Analysis of Reported Compact Position Reporting (CPR) Anomalies in Operational Airspace

Case 1: Airborne Position Message, Odd Encoding Aircraft Identification = VOZ858

Case 2: Airborne Position Message, Odd Encoding Aircraft Identification = VOZ858

Figure 1: Boundary Crossing at NL=47 to NL=48

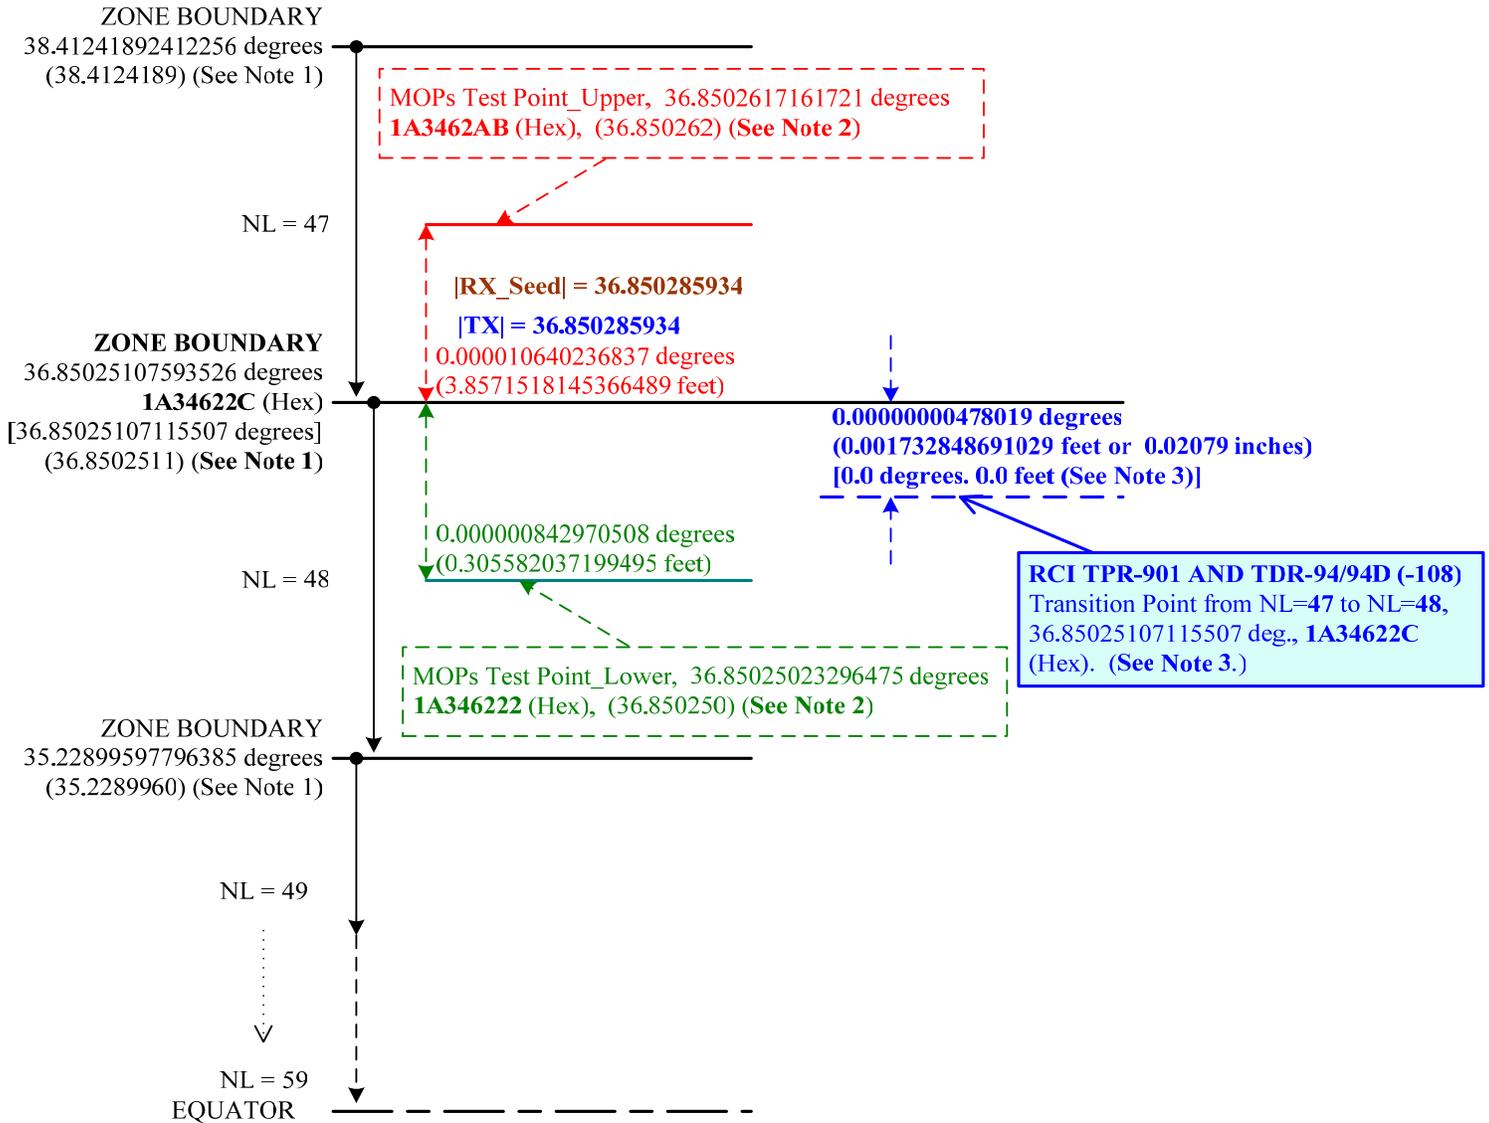
The reporting agency reported that the following Airborne Position Message was received by the Ground Station and considered to be in error in regards to Encoded Longitude.

The reporting authority indicated that the transponder may not be executing a proper latitude zone look-up in accordance to the applicable specification. If such were the case, then the error would be as demonstrated in the table above.

At this point, the results of the simulations and testing were reported to the reporting agency. However, concerns remained that the transponder appeared to be establishing the message encodings based on a latitude zone lookup of **NL=48**, as opposed to **NL=47**.

Referring to **Figure 1**, it is clear that the input latitude position of -36.850285934 (Negative for South) is 36.850285934 degrees from the equator which is **further from** the equator than the boundary located at 36.85025107593526 degrees. Therefore, the proper zone to be using for encoding or decoding at this latitude is **NL = 47**.

Figure 1 illustrates that the TPR-901 and TDR-94/94D (-108) transponders switch from **NL=47** to **NL=48** exactly at **1A34622C** (Hex). As this is the best that the designated boundary can be encoded in Angular Weighted Binary and retain an accuracy of +/- 1/2 LSB, the TPR-901 and TDR-94/94D (-108) transponders appear to be switching **NL** boundaries **EXACTLY** as required and there is **NO** error.

When referred to the input boundary value of 36.85025107593526 degrees, the error is extremely minute with the transponders switching to **NL=47** 0.00000000478019 degrees **prior to** reaching the boundary. As the switch point is **prior to** the boundary, the case in point for selecting **NL=47** for the given input latitude is **aided** as opposed to being **degraded**, and the transponders will select a value of **NL=47** as demonstrated in simulation and in testing.

Figure 1 also indicates that the Transmitter Latitude is **further from** the equator than the AWB boundary established at 36.85025107115507 degrees and the boundary computed at 36.85025107593526 degrees. Therefore, the Transmitter should use **NL=47** for encoding purposes.

Likewise, **Figure 1** also indicates that the Receiver Seed Latitude is **further from** the equator than the AWB boundary established at 36.85025107115507 degrees and the boundary computed at 36.85025107593526 degrees. Therefore, the Receiver should use **NL=47** for decoding purposes.

Figure 2: Boundary Crossing at NL=52 to NL=53

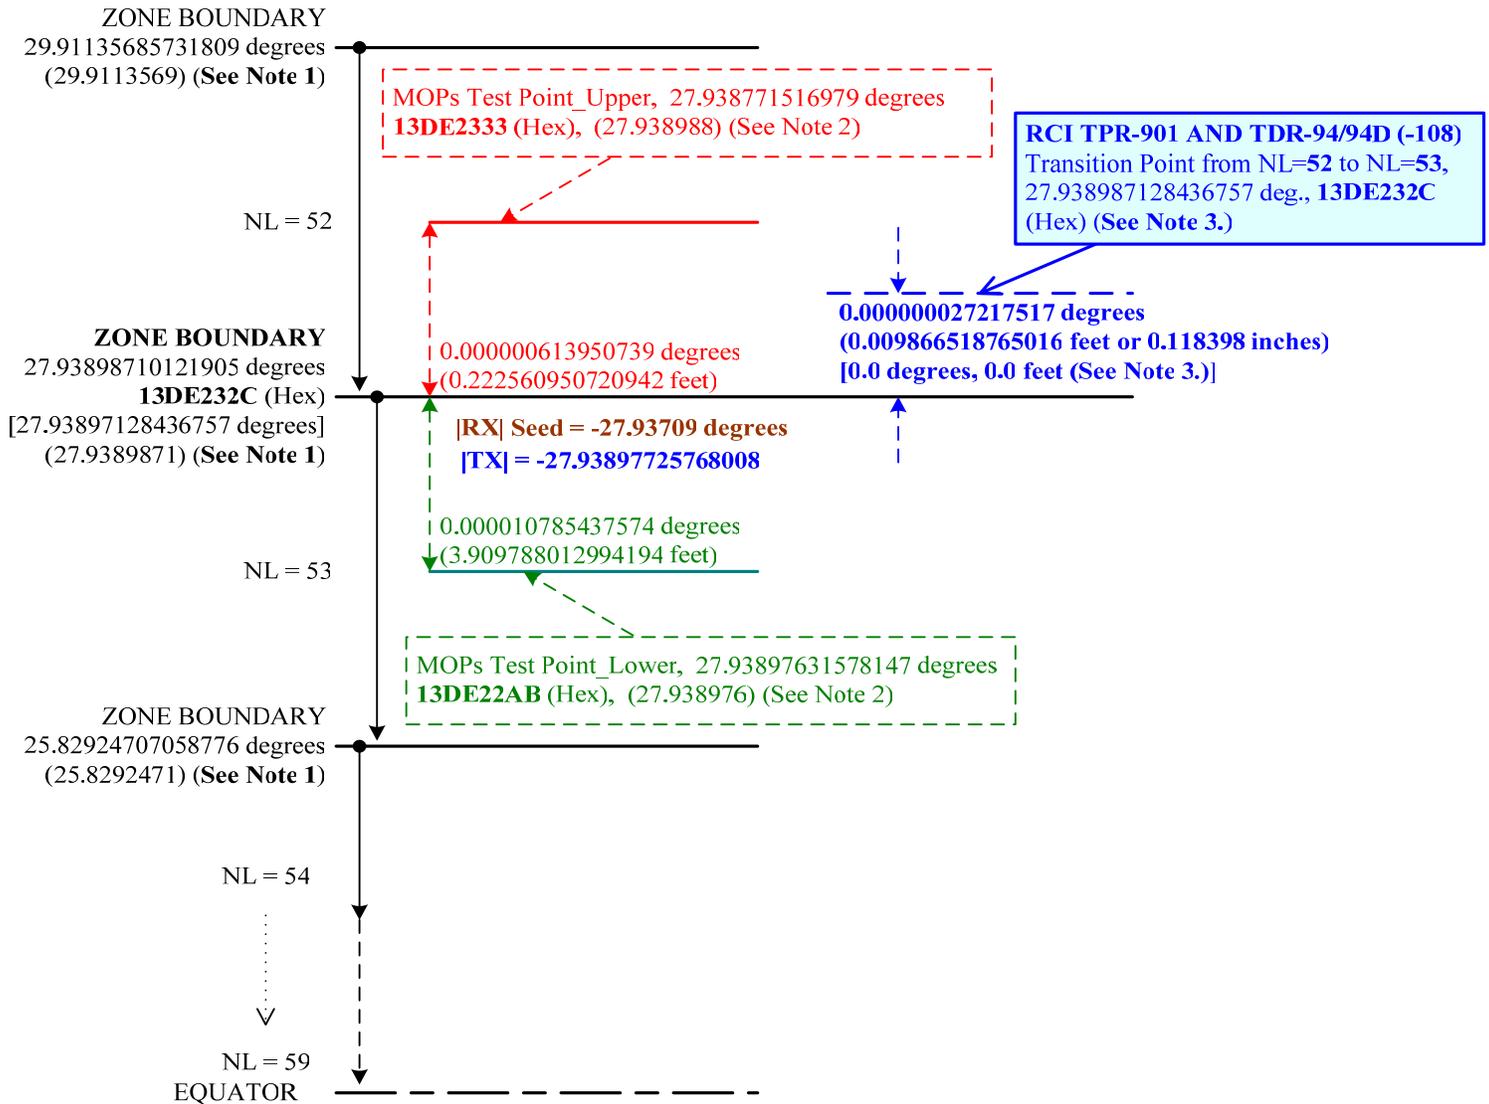
The reporting agency reported that the following Airborne Position Message was received by the Ground Station and considered to be in error in regards to Encoded Longitude.

The reporting authority indicated that the transponder may not be executing a proper latitude zone look-up in accordance to the applicable specification. If such were the case, then the error would be as demonstrated in the table above.

As the reporting agency indicated that the proper latitude encoding should be **033F0** (Hex) and the **NL** should be **52**, both the TPR-901 and TDR-94/94D (-108) transponders were subjected to detailed testing to establish exactly where the transponders established the zone boundary between **NL=52** and **NL=53**. **Figure 2** illustrates the location of the exact boundary crossing between **NL=52** and **NL=53**, as well as the limits that are tested in RTCA DO-260A, Section 2.4.3.2.4.7.1.1, **Table 2-130**. Likewise, **Figure 2** illustrates exactly where the TPR-901 and TDR-94/94D (-108) transponders are transitioning from **NL=52** to **NL=53**.

Referring to **Figure 2**, it is clear that the input latitude position of -27.92897725768008 degrees (Negative for South) is 27.92897725768008 degrees from the equator which is **closer to** the equator than the boundary located at 27.93898710121905 degrees. Therefore, the proper zone to be using for encoding or decoding at this latitude is **NL = 53** as illustrated in **Figure 2**.

When referred to the input boundary value of 27.93898710121905 degrees, the error is extremely minute with the transponders switching to **NL=53** 0.000000027217517 degrees **after** the boundary. As the switch point is **after** the boundary, the case in point for selecting **NL=52** for the given input latitude is **degraded** as opposed to being **aided**, and the transponders will select a value of **NL=53** as demonstrated in simulation and in testing.

Figure 2 indicates that the Transmitter Latitude is **closer to** the equator than the AWB boundary established at 29.93897128436757 degrees and the boundary computed at 27.92897725768008 degrees. Therefore, the Transmitter should use **NL=53** for encoding purposes.

Likewise, **Figure 2** indicates that the Receiver Seed Latitude is **closer to** the equator than the AWB boundary established at 29.93897128436757 degrees and the boundary computed at 27.92897725768008 degrees. Therefore, the Receiver should use **NL=53** for decoding purposes.
